SUBJECT: **R.E. Ginna Nuclear Power Plant**
Docket No. 50-244

Application to Revise Technical Specifications Regarding Control Room Envelope Habitability in Accordance With TSTF-448, Revision 3, Using the Consolidated Line Item Improvement Process

Proposed Technical Specification Changes (Mark-UP)

Figure B 3.7.9-1
CREATS

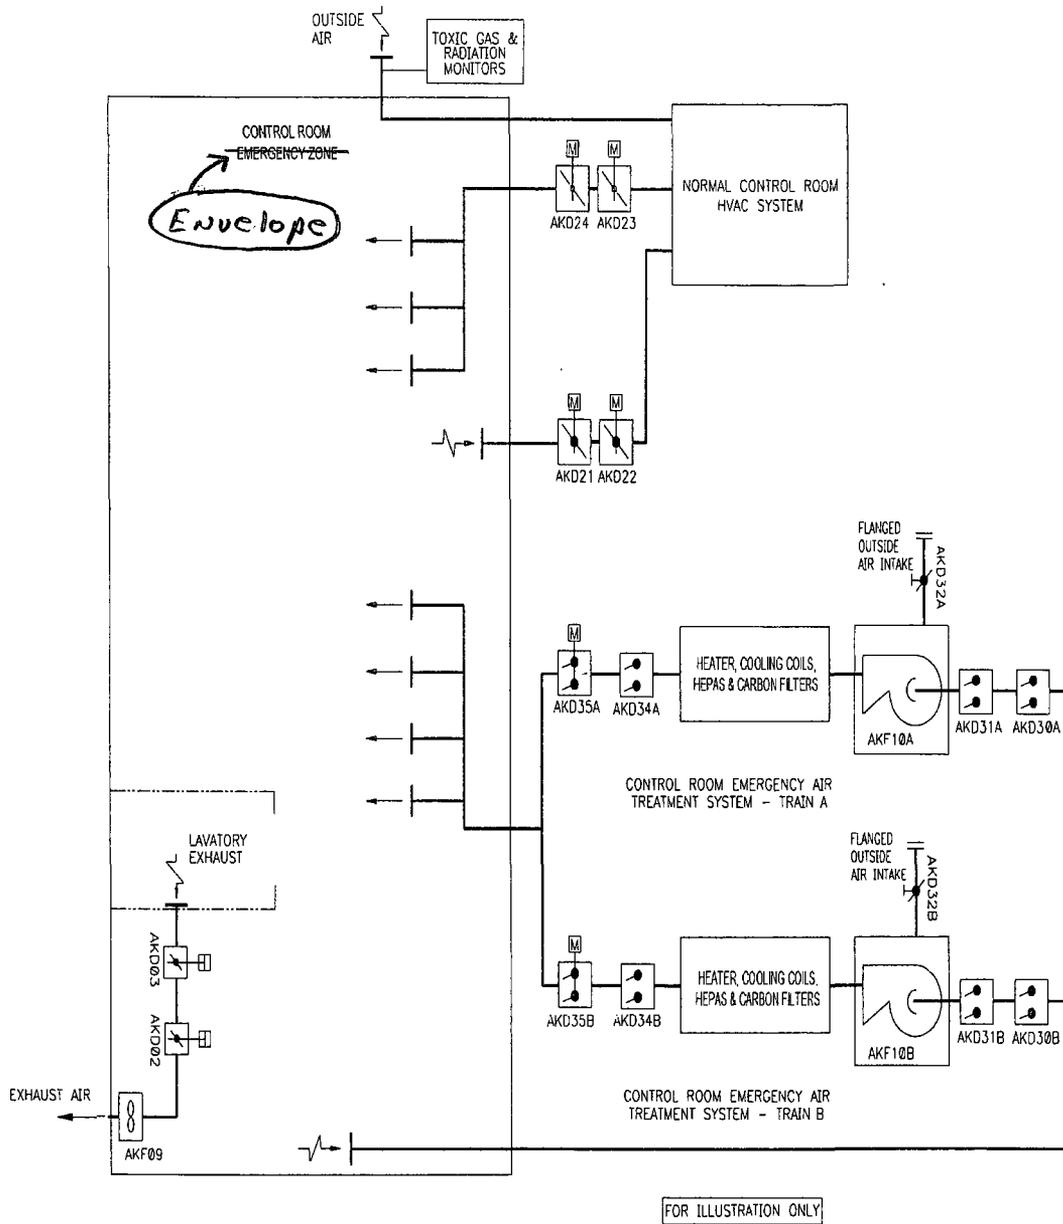
The CREATS consists of two trains, each containing a high efficiency particulate air (HEPA) filter, activated charcoal adsorbers for removal of gaseous activity (principally iodines), and one fan (see Figure B 3.7.9-1). Ductwork, dampers, and instrumentation also form part of the system (Ref. 3).

~~The CREATS is considered OPERABLE when the individual components necessary to permit CREATS operation are OPERABLE (see Figure B 3.7.9-1). A CREATS train is OPERABLE when the associated:~~

The air entering the CRE is continuously monitored by radiation and toxic gas detectors. Detector output above the setpoint will cause actuation of the CREATS. Redundant recirculation trains provide the required filtration should a fan fail to start or an excessive pressure drop across the other filter train develops. Normally open isolation dampers are arranged in series pairs so that the failure of one damper to shut will not result in a breach of isolation. The CREATS is designed in accordance with Seismic Category I requirements.
